Service Update

SU 2302 7.3L RADIATOR COOLANT LEAKS

Models Affected: Model Year 2021 thru current model BBCV buses equipped with Ford 7.3L engine.

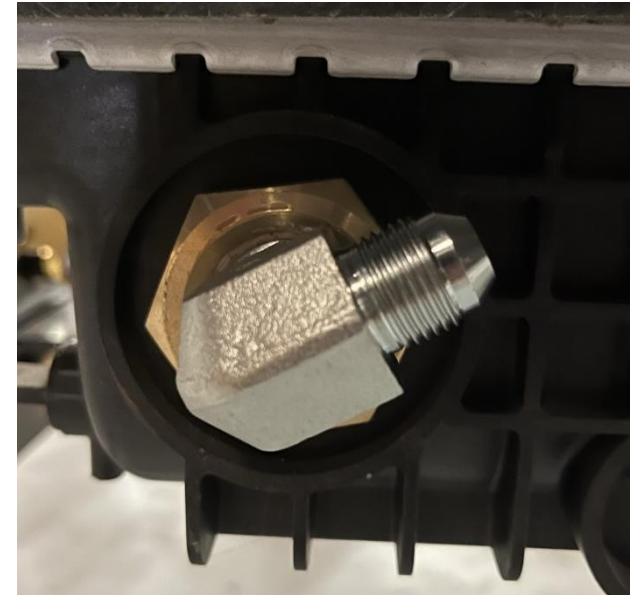
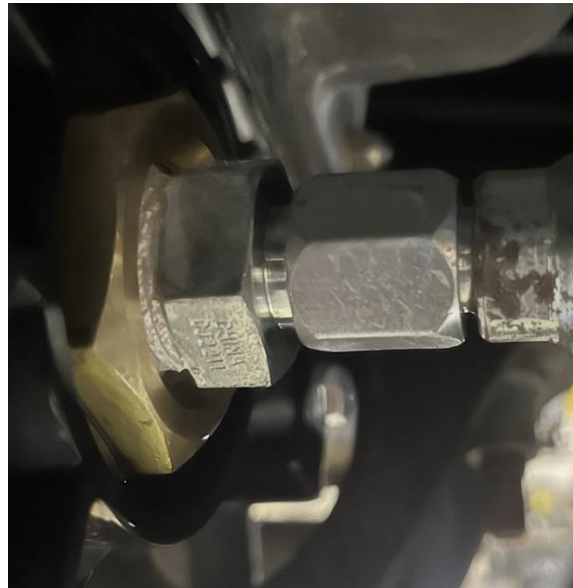
Issue: Coolant leaks at the transmission cooler fitting(s) have been found on certain radiators due to deformation of the EPDM gasket used to seal the transmission cooler to the lower radiator tank. This deformation is caused from transmission oil wicking through the thread adapter threads and exposing the lower portion of the gasket to transmission oil.

Corrective Action: Re-configure hydraulic interface between the transmission cooler lines and the transmission oil cooler.

12) Apply 242 and install both brass nuts that came in the 10059342 kit, using the pipe nipples to help position the cooler. Once hand tight, remove nipple at that location. Torque nuts to 28 Ft-LBS (38 N-M).

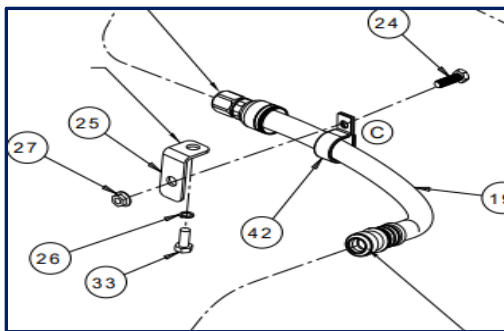
- 13) Remove pipe nipple, apply Loc-Tite™567 to NPT threads, and Install 10081789 90° fitting into the left/driver's side cooler port. Clock fitting as shown below.
- 14) Remove pipe nipple, apply Loc-Tite™ 567 to the NPT threads, and Install 10081790 straight fitting into the right/passenger side cooler port.

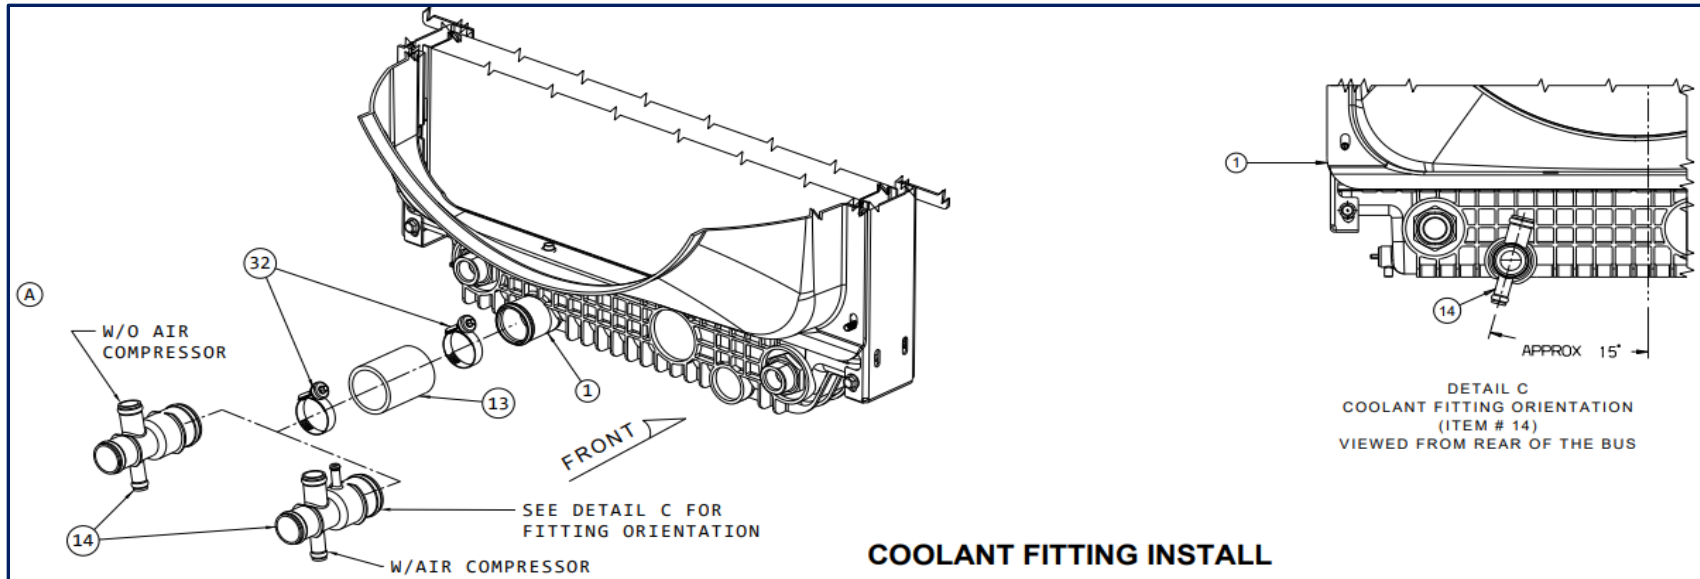
- 15) Verify P clamp from passenger side cooler line is configured, per the below illustration. Make corrections if not.
